SOCIETY HILL LOCATION

**Revised Preliminary Site Plan Submission
March 2024**

RE: Society Hill - Revision to 1999 Final Site Plan

Figure 1. City of Novi Regulated Woodlands Map

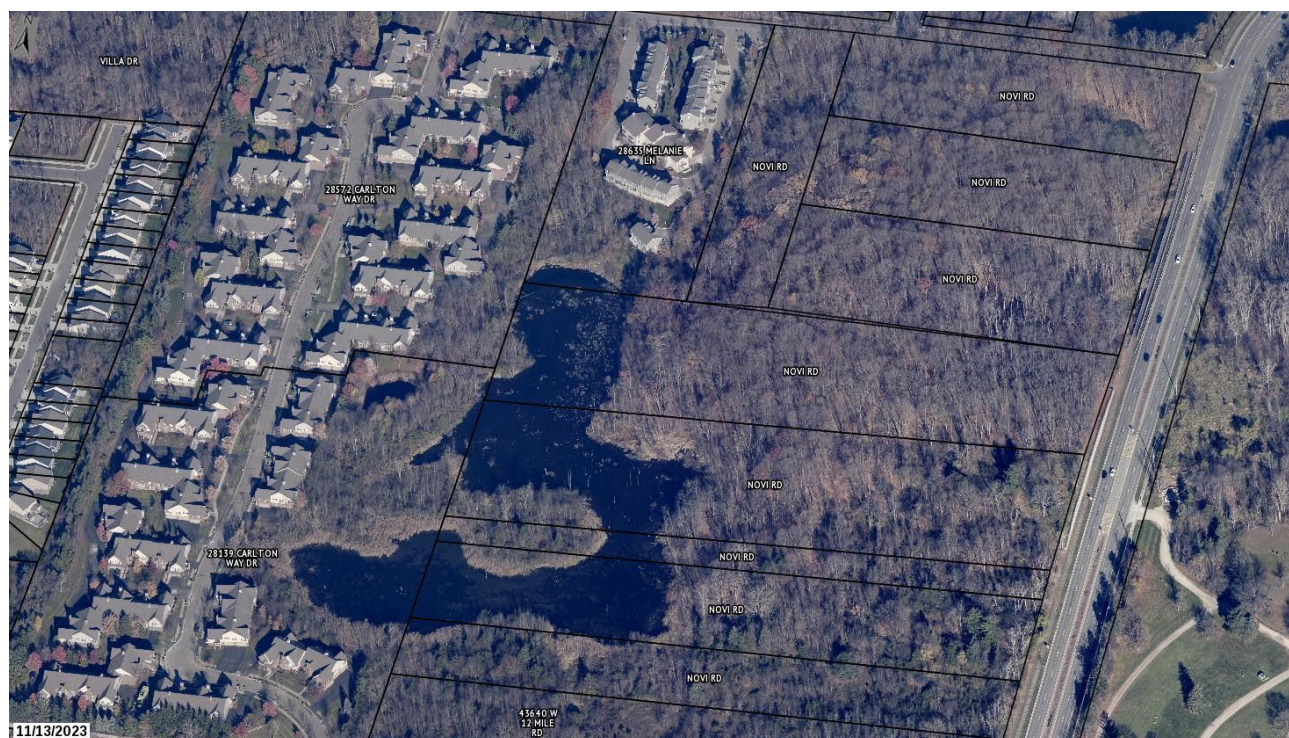
1. City-regulated woodlands, as identified on the City of Novi Woodlands interactive map website, are present onsite. **Note that both the woodlands and property limits depicted on the City map are considered approximations (Figure 1).** Pursuant to Section 37-2 and Section 37-4 of Chapter 37, Woodlands Protection, woodland areas can be identified by additional features such as soil quality, habitat quality, tree species and diversity, health and vigor of tree stand, understory species and quality, presence of wildlife, and other factors such as the value of the woodland area as a scenic asset, wind block, noise buffer, healthy environment, and the value of historic or specimen trees. A site visit was performed on April 12 and 15, 2024 to verify and review the extent of woodlands on-site. Merjent has

determined that the majority of the trees on-site should be considered regulated woodland due to the stand density and connectivity to other larger regulated woodland areas. Additionally, various wildlife such as raccoons (*Procyon lotor*), wild turkeys (*Meleagris gallopavo*), and mallard ducks (*Anas platyrhynchos*) were seen throughout the site. **Figure 1** (attached) has a modified polygon showing the additional approximate woodland areas onsite. Select photos from the site visits are included in **Attachment A**.

Figure 2. City of Novi Regulated Wetlands Map
 Approximate Site boundary is shown in red.
 (Approximate) Regulated Wetland areas are shown in turquoise.

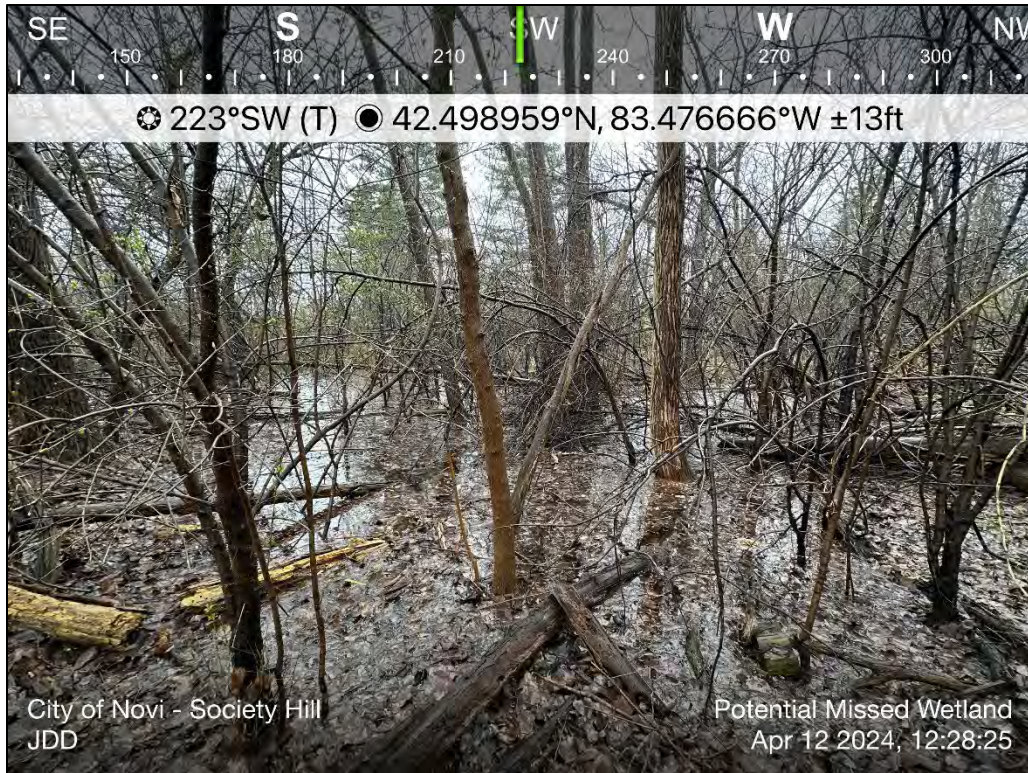
- ☒ City-regulated wetlands, as identified on the City of Novi interactive map website. Note that both wetland and property limits depicted on the City's map are considered approximations (**Figure 2**).
- ☒ Wetlands that are regulated by the Michigan Department of Environment, Great Lakes, and Energy (EGLE).
- ☒ Wetlands as identified on National Wetland Inventory (NWI) and Michigan Resource Inventory System (MIRIS) maps, as identified on the EGLE Wetlands Viewer interactive map website (**Attachment B**). NWI and MIRIS wetlands are identified by the associated governmental bodies' interpretation of topographic data and aerial photographs.
- ☒ Hydric (wetland) soil as mapped by the U.S. Department of Agriculture, Natural Resources Conservation Service, as identified on the EGLE Wetlands Viewer interactive map website (**Attachment B**).

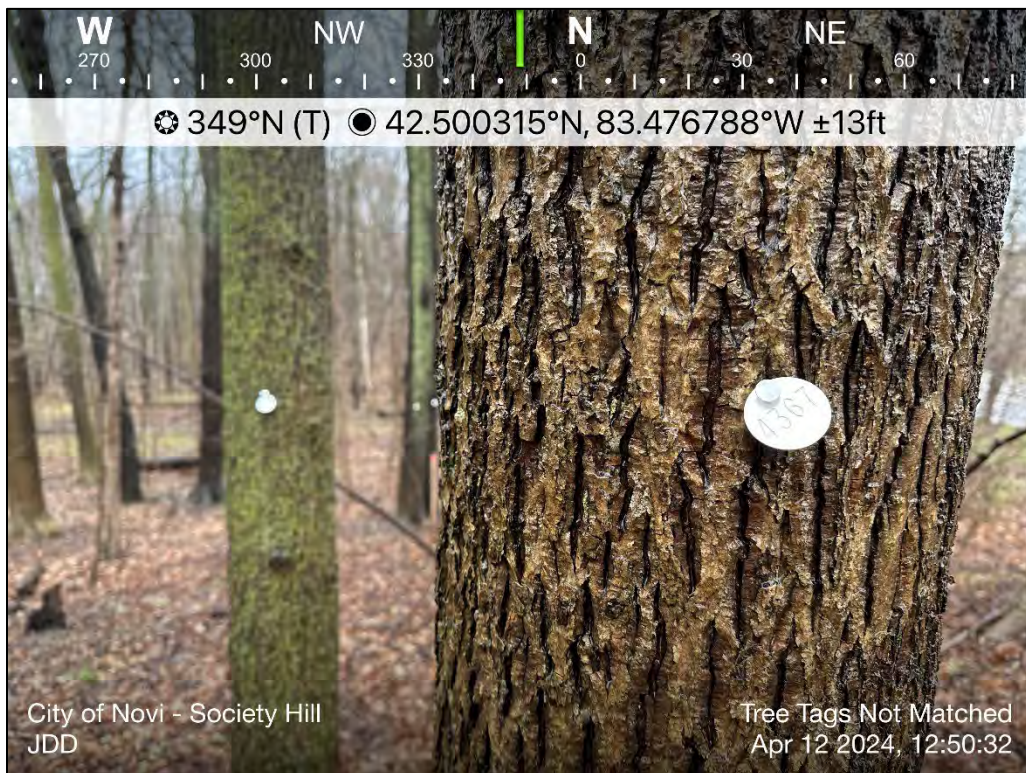
Overview of a tree tag that does not match the survey. This tree is approximately located around Tree 679 identified in the PSP. Tree tag reads as 4339.

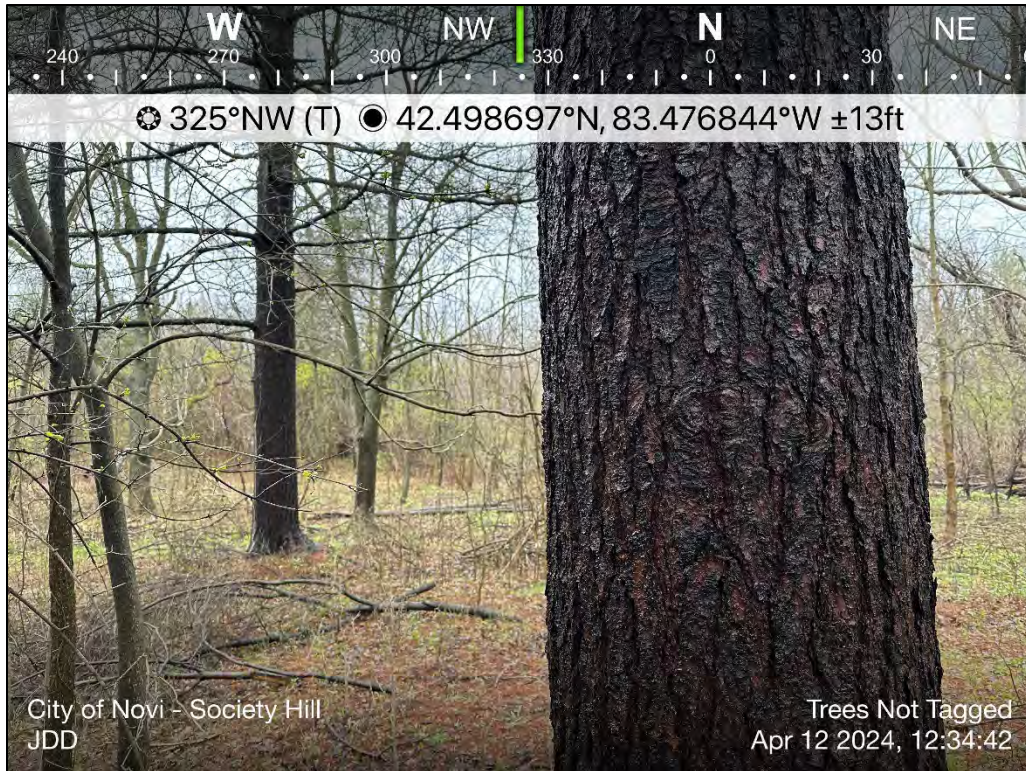
Overview of a tree tag that does not match the survey. This tree is approximately located around Tree 1104 identified in the PSP. Tree tag reads as 4367.

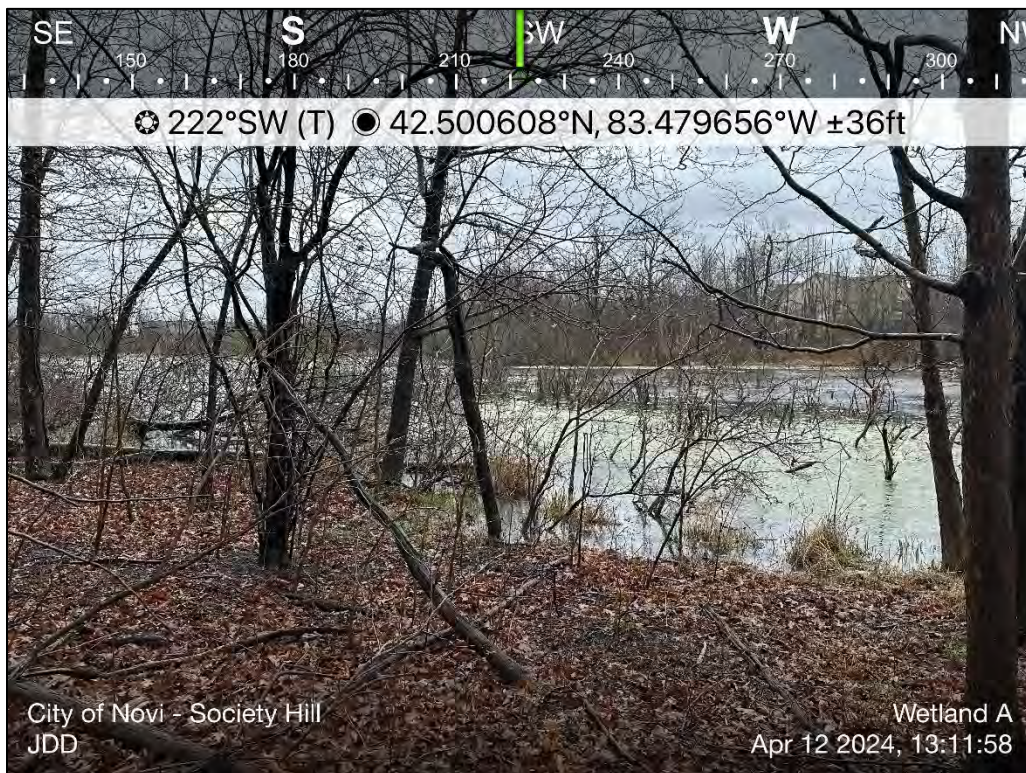
Many trees onsite did not contain any markings/tags. The trees photographed are proximal to Tree 1740 identified in the PSP.

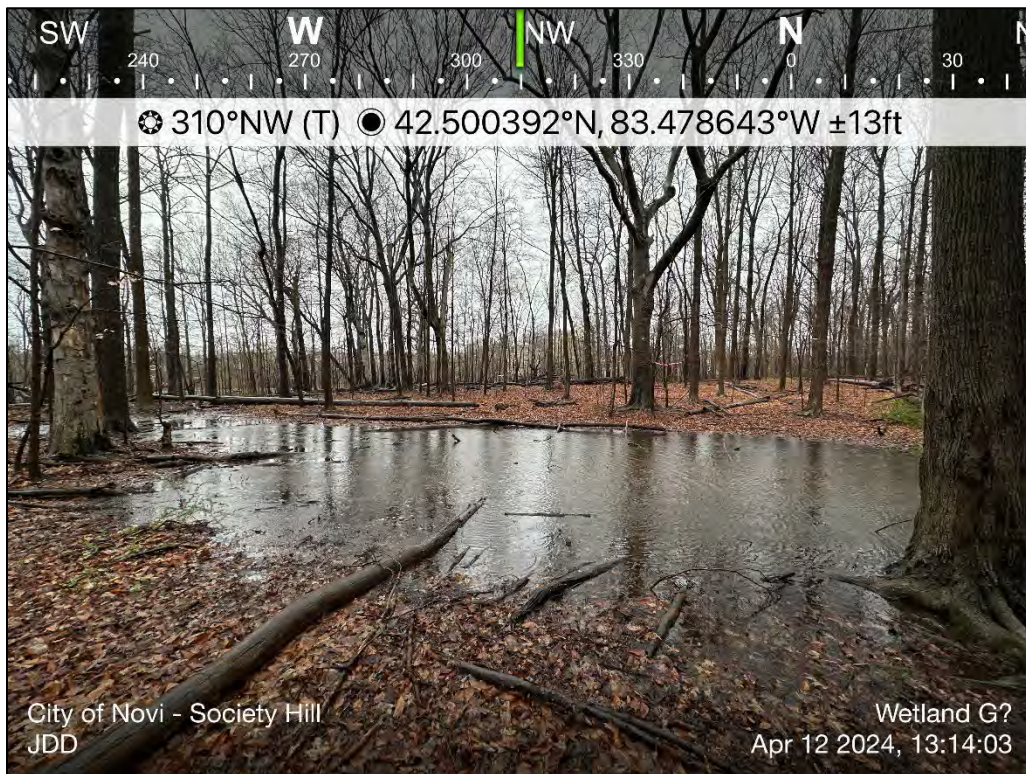
Overview of Wetland G, which is not identified on sheet two.

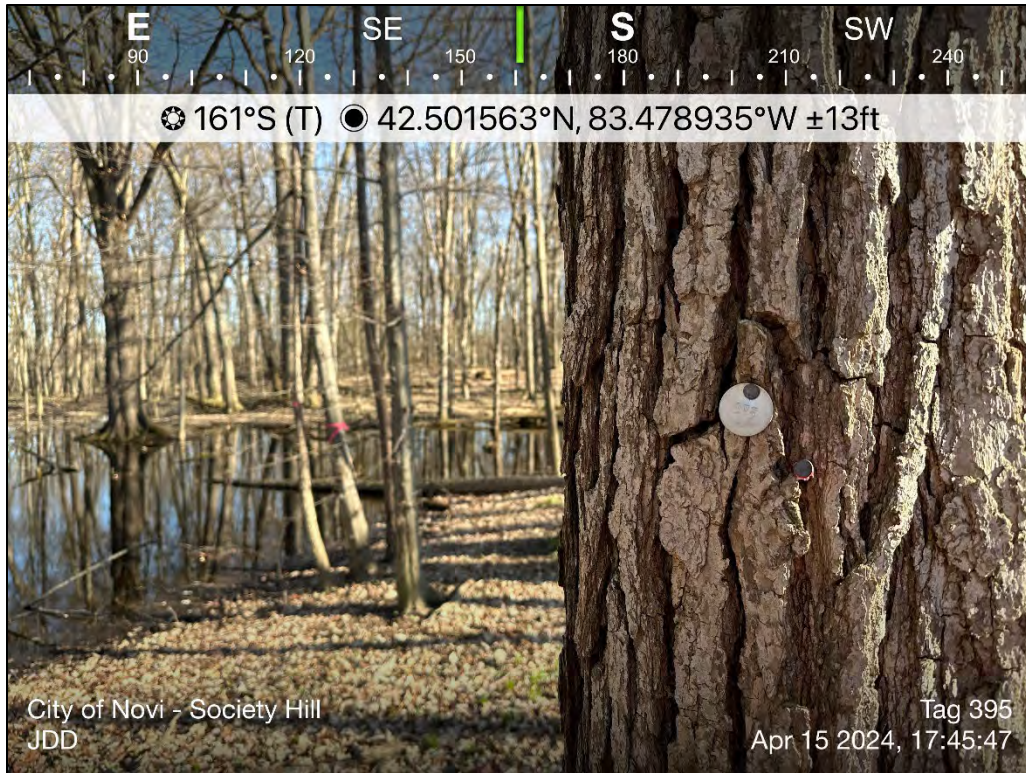
Overview of a tree tag that does not match the survey. This tree is approximately located around Tree 469 identified in the PSP. Tree tag reads as 395.

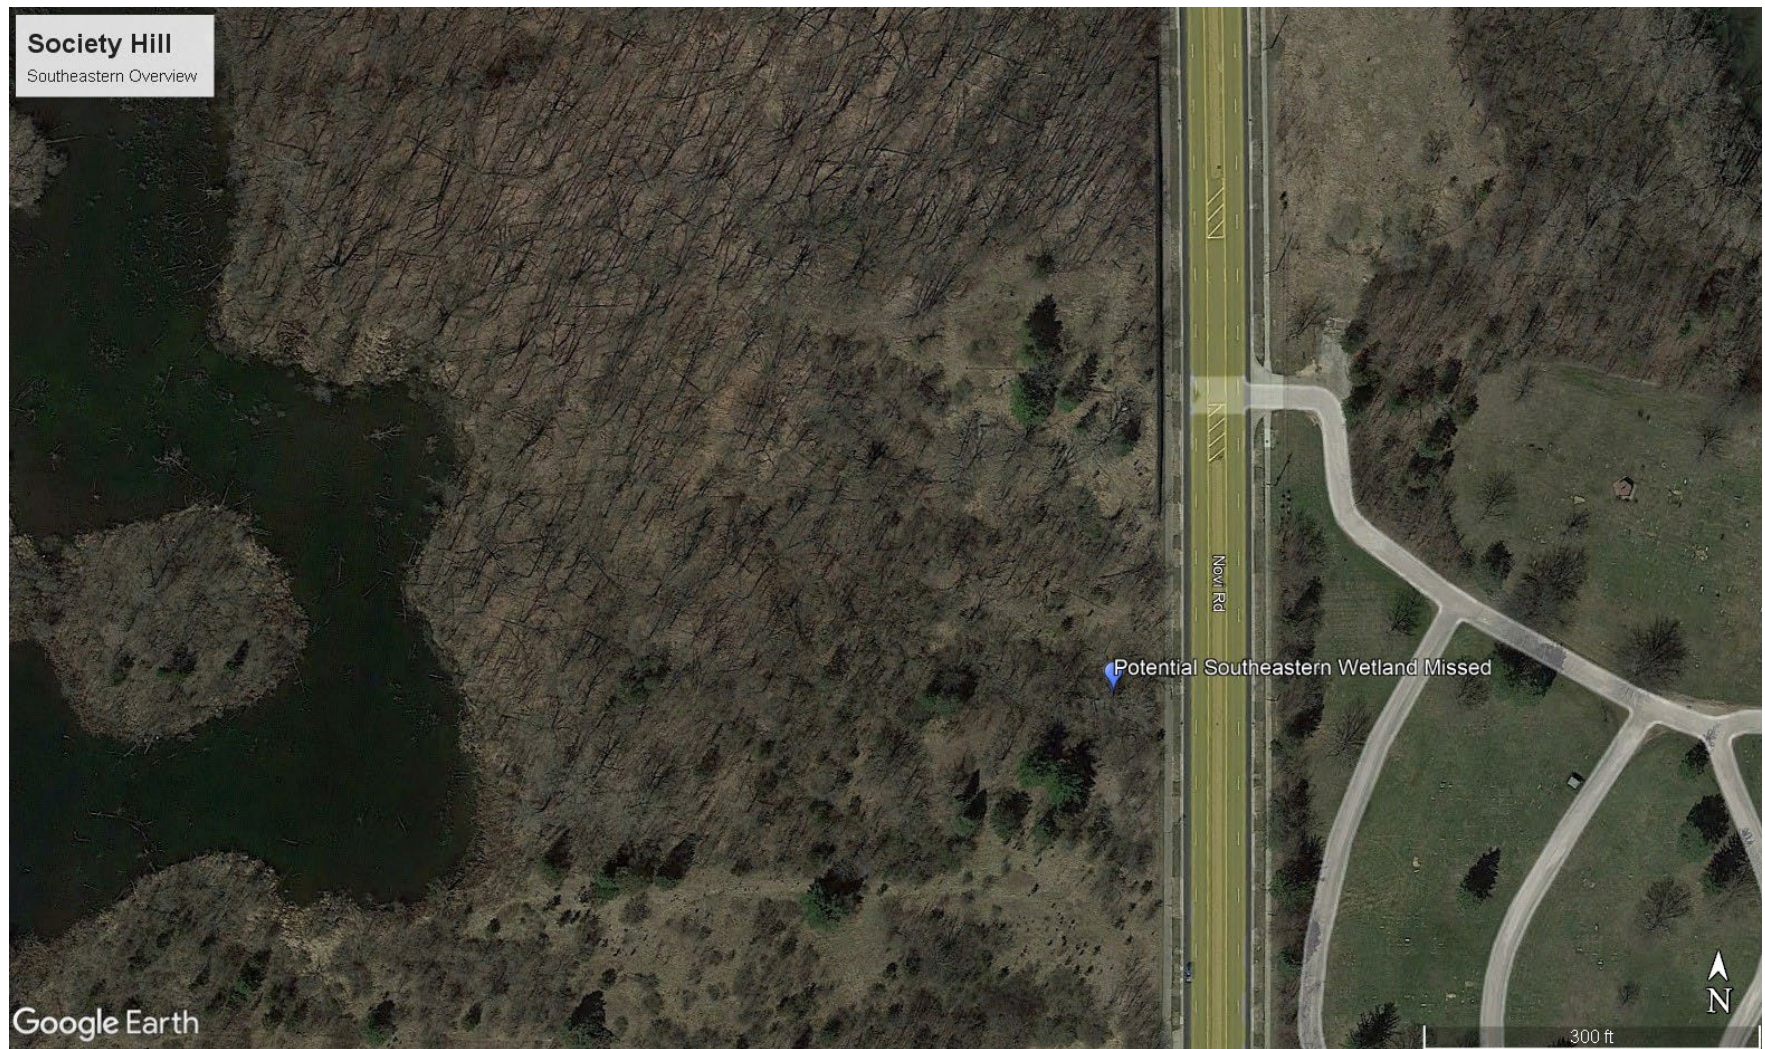
Overview of the northern portion of the site with potentially missed wetlands. Photographs of each area are included in **Attachment A**.

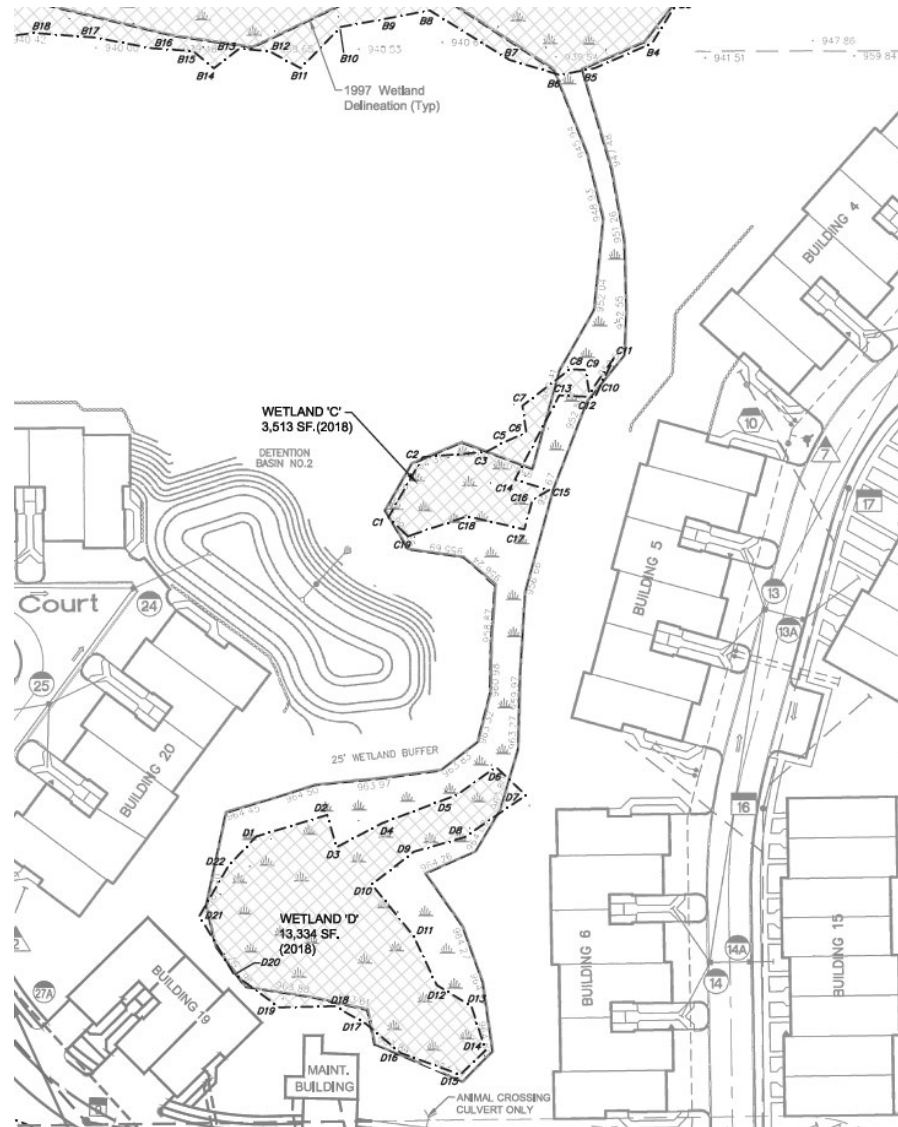
Overview of the southeastern portion of the northern parcel with a potentially missed wetland. Photographs of the area are included in **Attachment A**.
